Bid Bulletin #01

PROJECT: Skinner Early Childhood Center
Bid Package #4
Omaha, NE

ADDENDUM E

Skinner Early Childhood Center
Omaha, Nebraska
RDG Project No. 2014.128.00, File 35.1

HM STORM DOOR HEAD

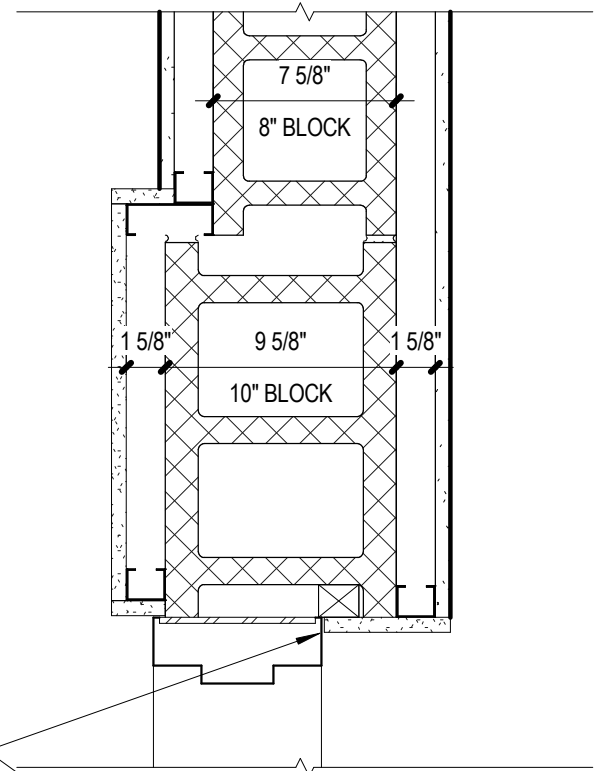
- A. Add Detail B1. See attached Supplemental Drawing SDA-002.
- B. Detail C3: Update bond beam to 10” block. See attached Supplemental Drawing SDA-002.

DOOR DETAIL

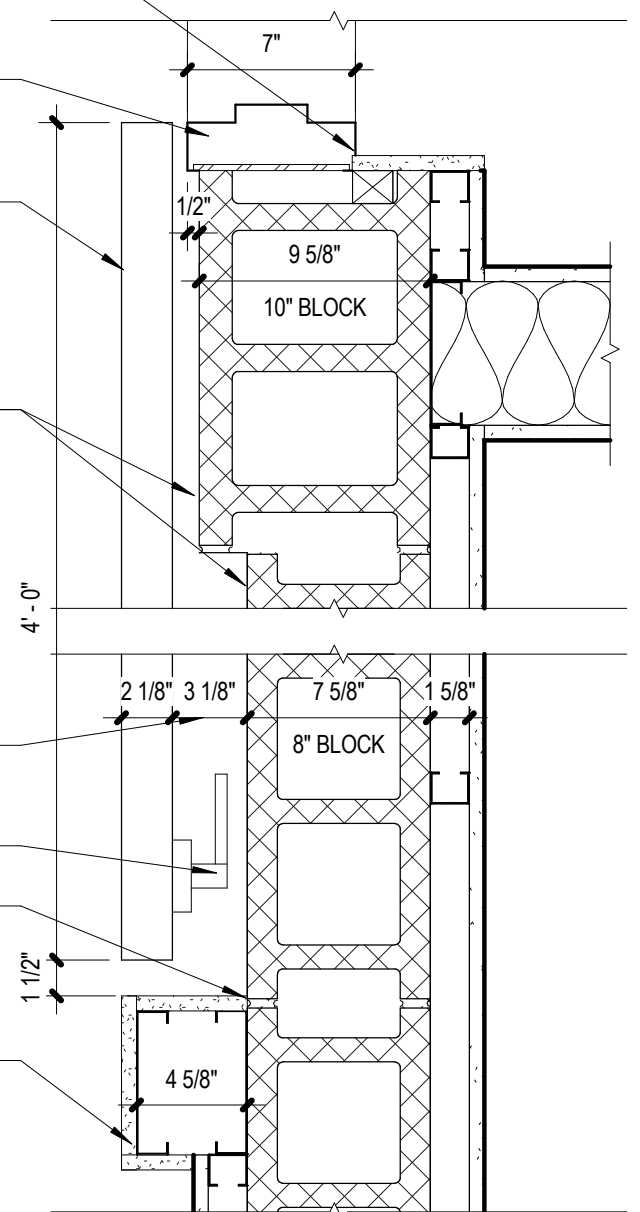
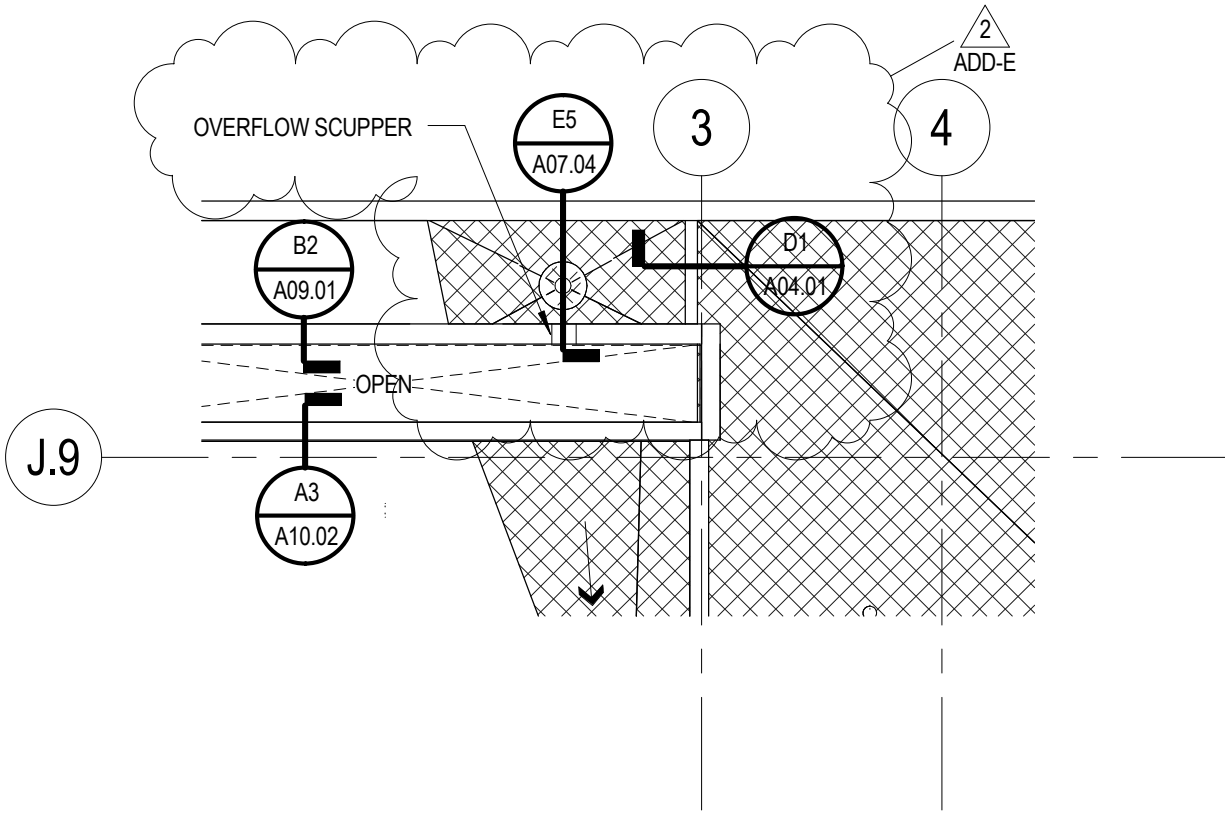
Sheet A10.01 – Door Schedule, Doors 193.1 and 194.1: Update door jamb detail to reference B1/A10.02.

ROOF PLAN

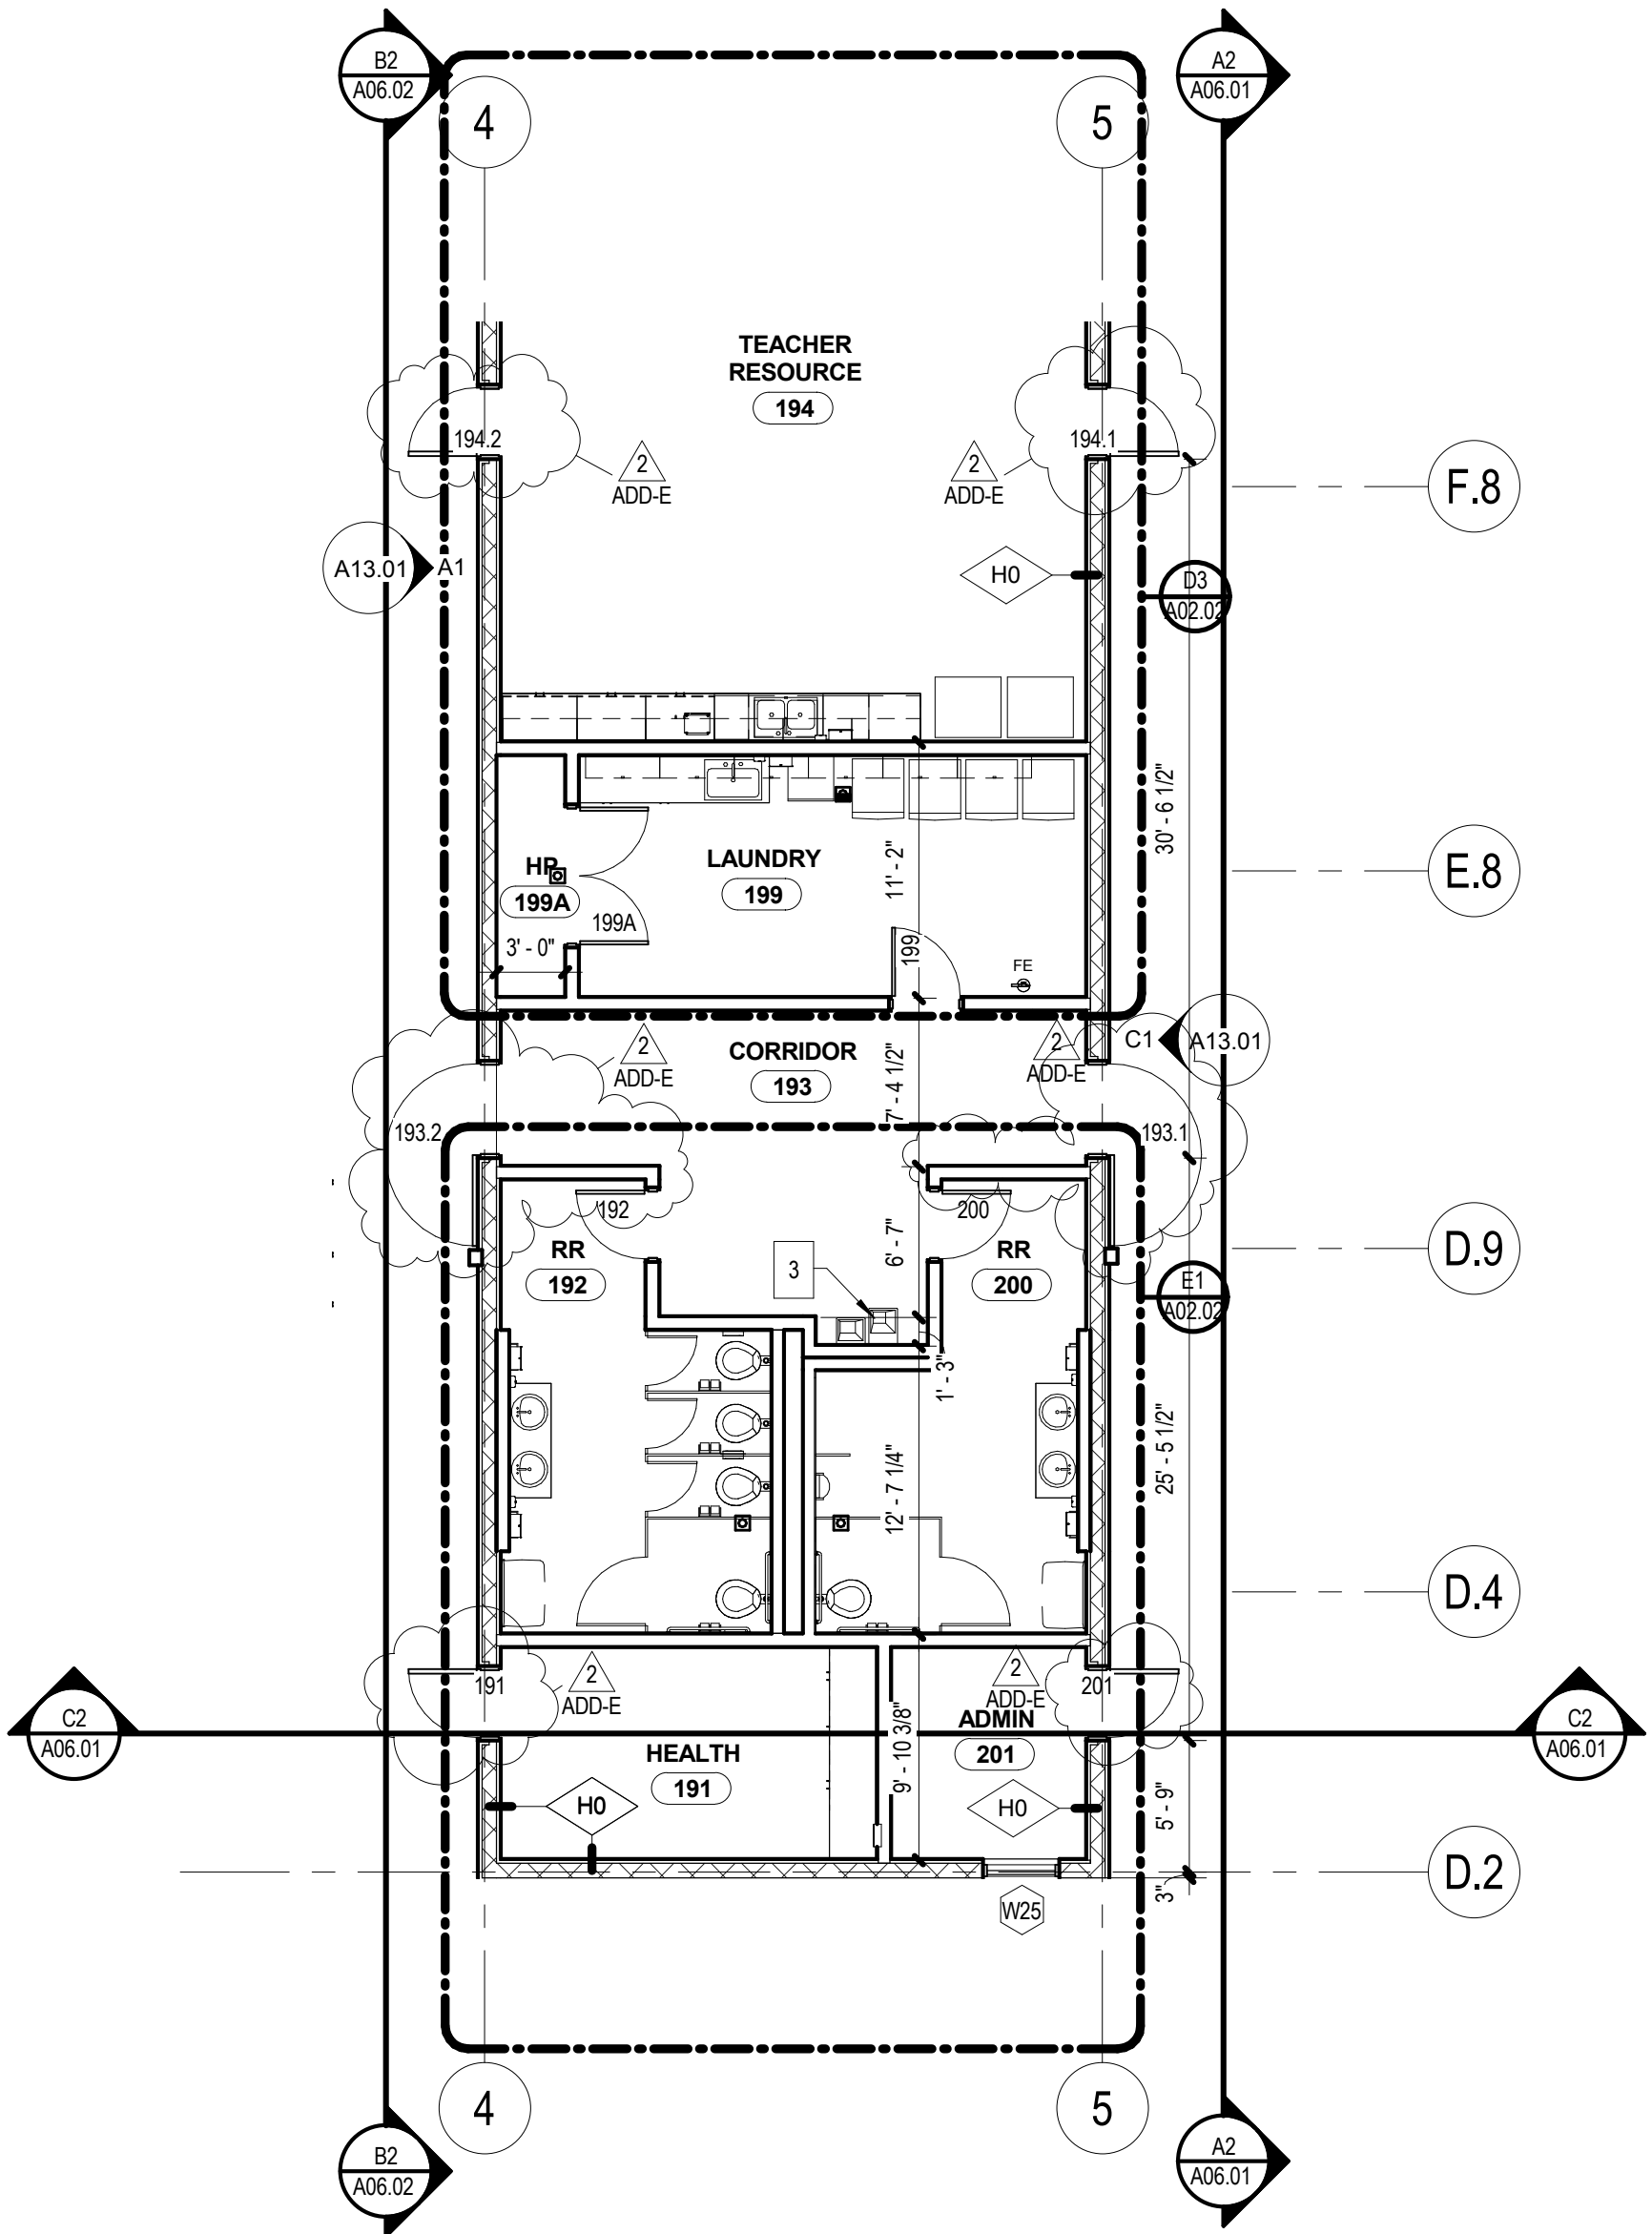
- A. Roof Plan: Add text note to locate overflow scupper and add detail references for roof drain/scupper and roof curb as shown on attached Supplemental Drawing SDA-003.
- B. Roof Drain Detail: Update Detail B1 vertical dimension text to read:

3” MIN. INSULATION AT ROOF DRAIN.

FLOOR PLAN

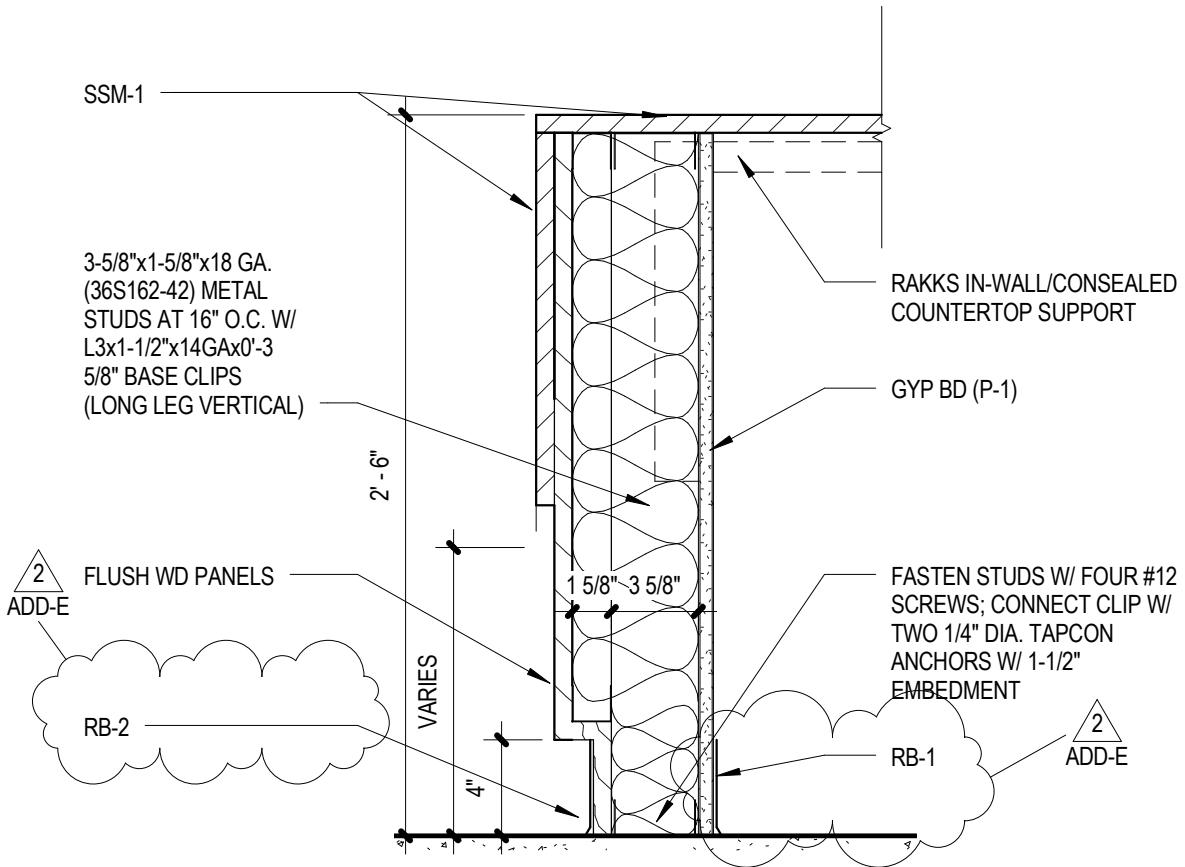
- A. Reverse swing direction of Doors 191, 193.1, 193.2, 194.1, 194.2, and 201.
- B. Remove furred out walls in Corridor 193. See attached Supplemental Drawing SDA-004.

A2 SECTION - DESK

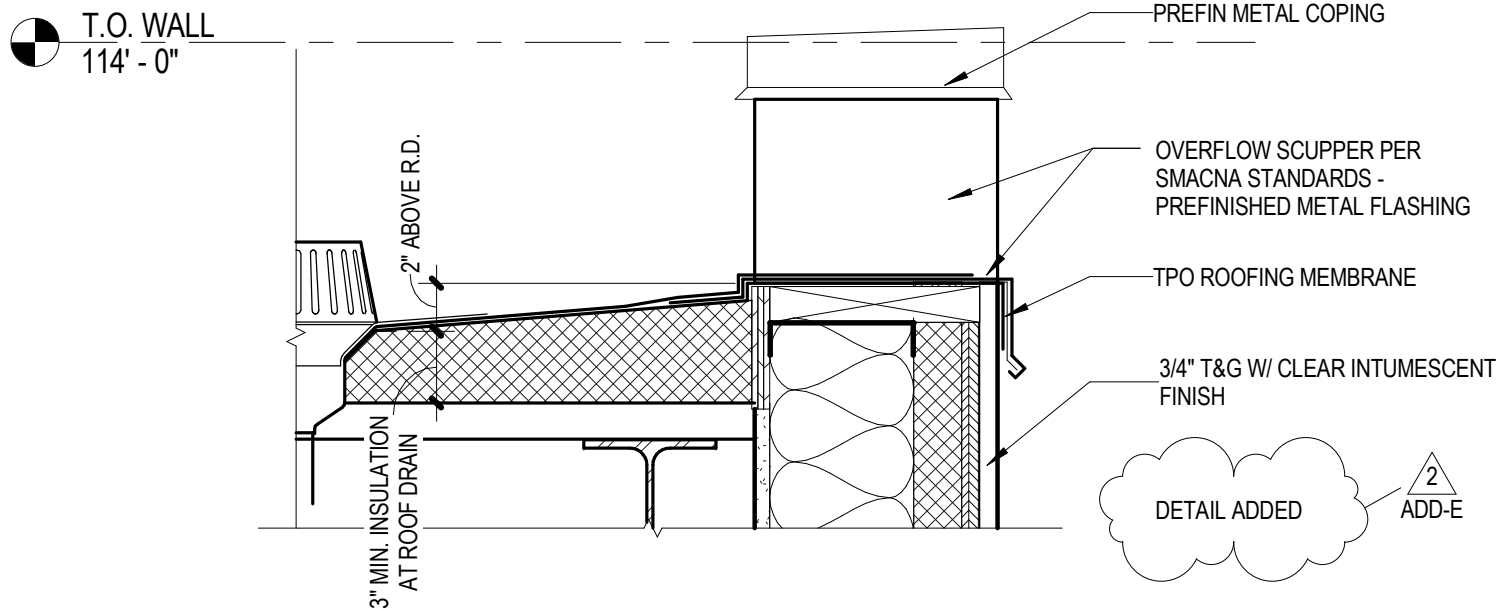
- A. Detail A2: Provide RB-2 wall base at 101 Gather side of reception desk; provide RB-1 on 102 Reception side of reception desk. See attached Supplemental Drawing SDA-005.
- B. Detail A5.1: Replace “CLEAR TEMPERED GLASS PANEL; MAINTAIN FLUSH TOP SURFACE” to read:

E5 ROOF SCRUPER DETAIL

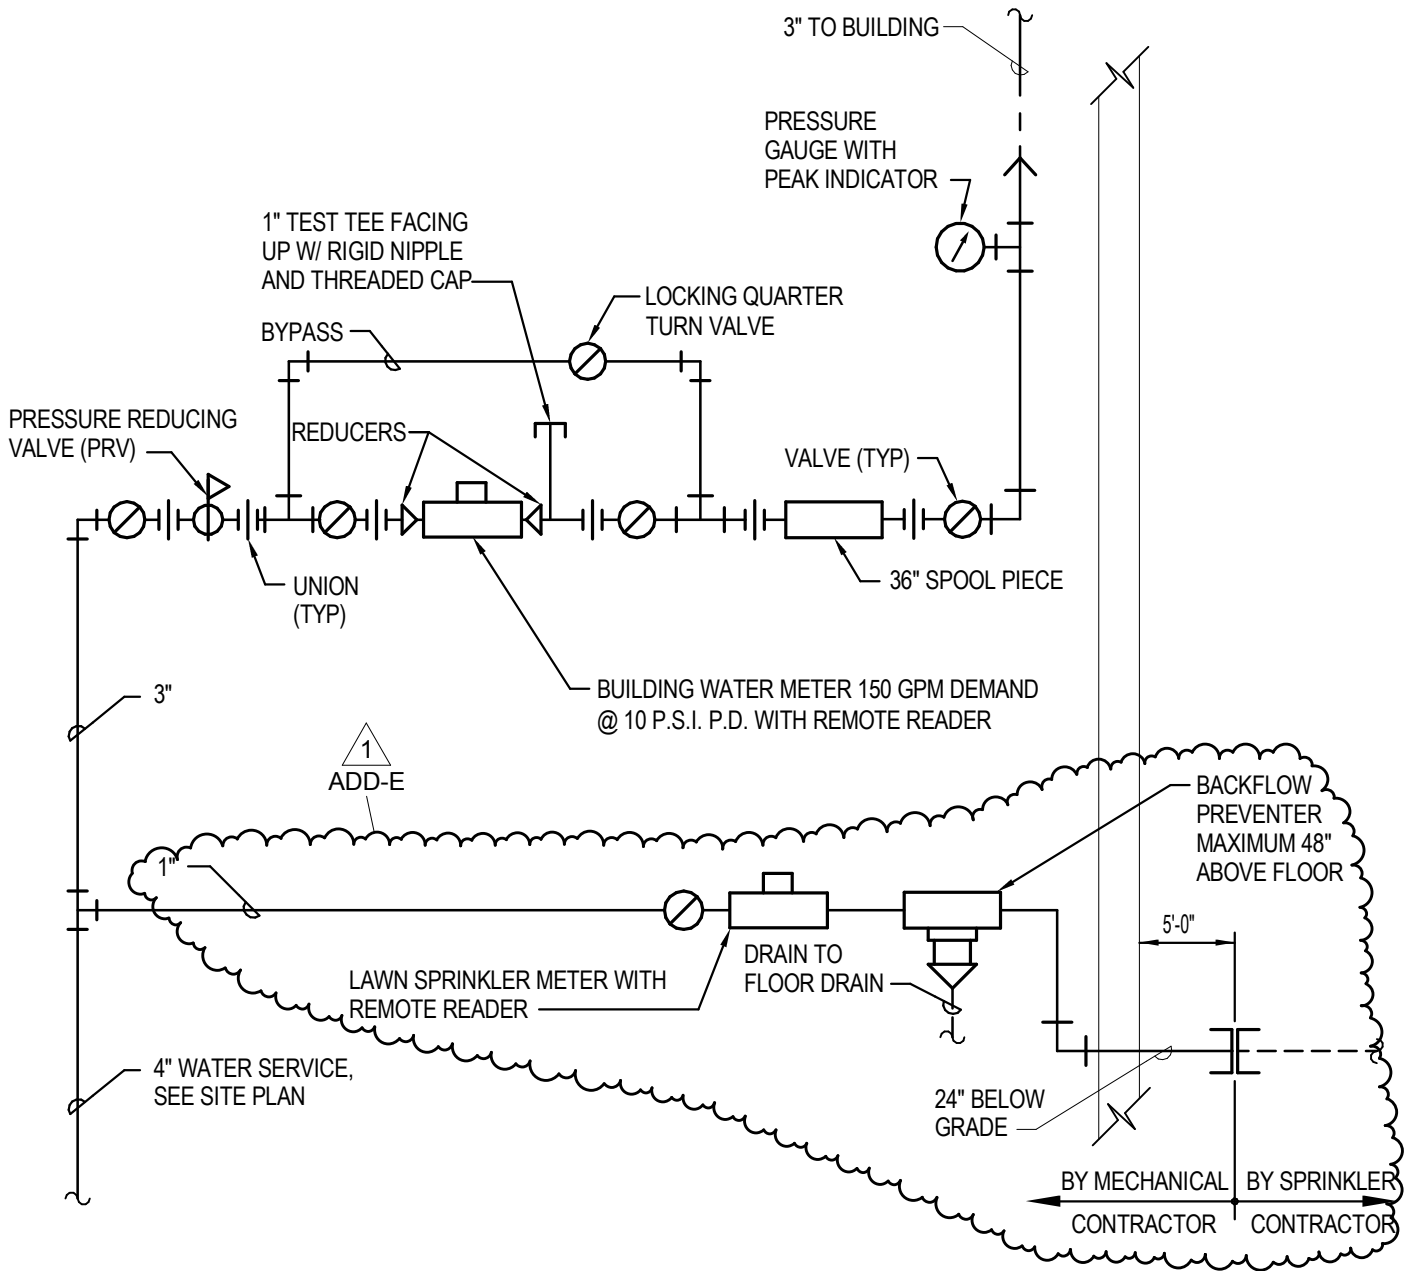
Sheet A07.04 – Wall Sections: Add scupper detail. See SDA-006.

WATER METER WITH LAWN SPRINKLER

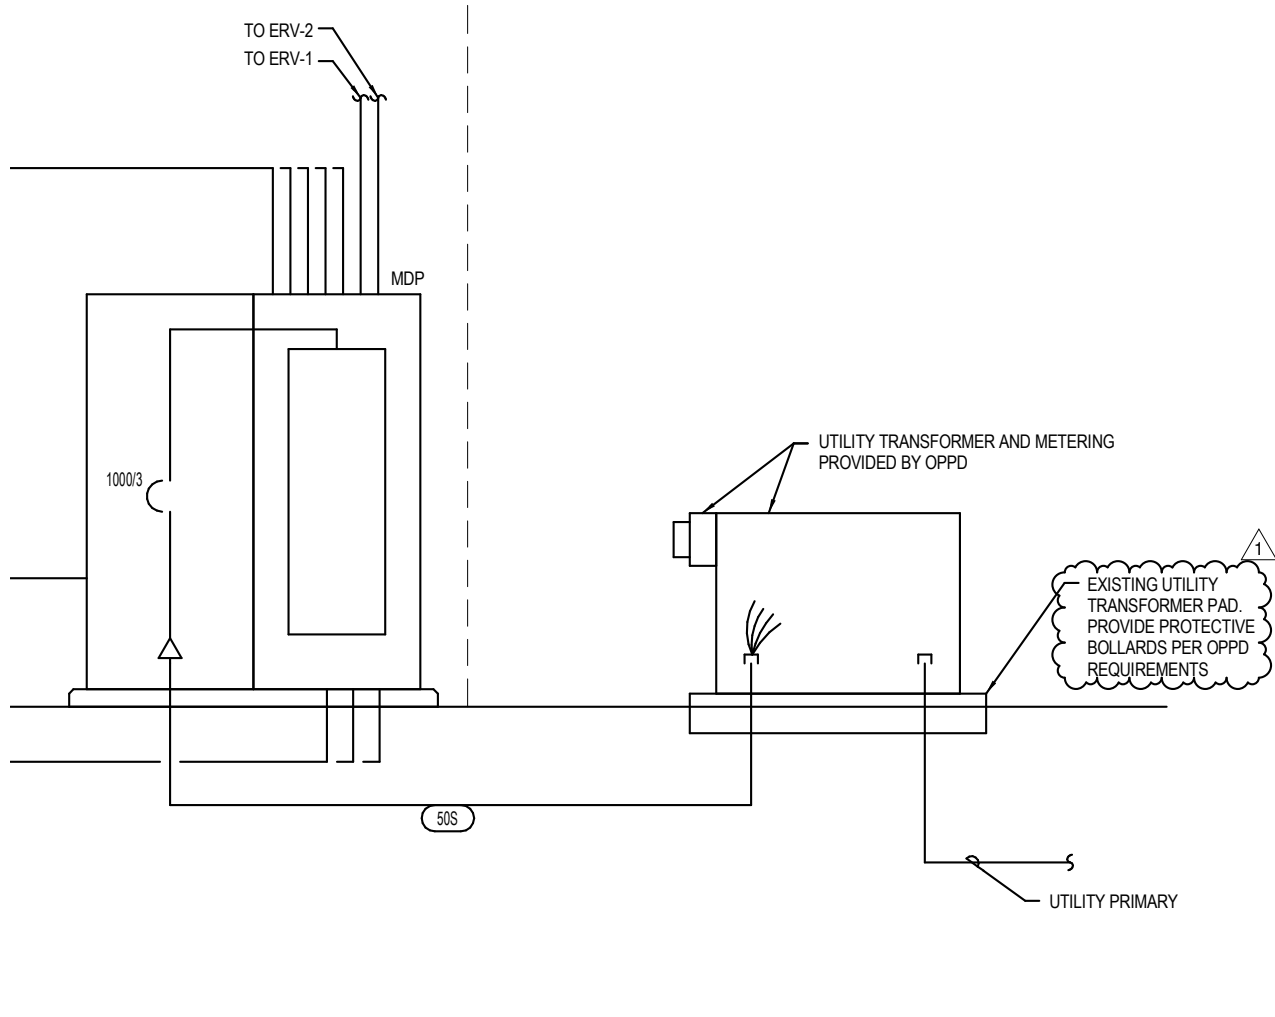
EMD-1 Sheet P4.0 – Plumbing Details: Revise irrigation system connection point to be located outside of building. See revisions as indicated on attached Mechanical Sketch Sheet SDP-001.
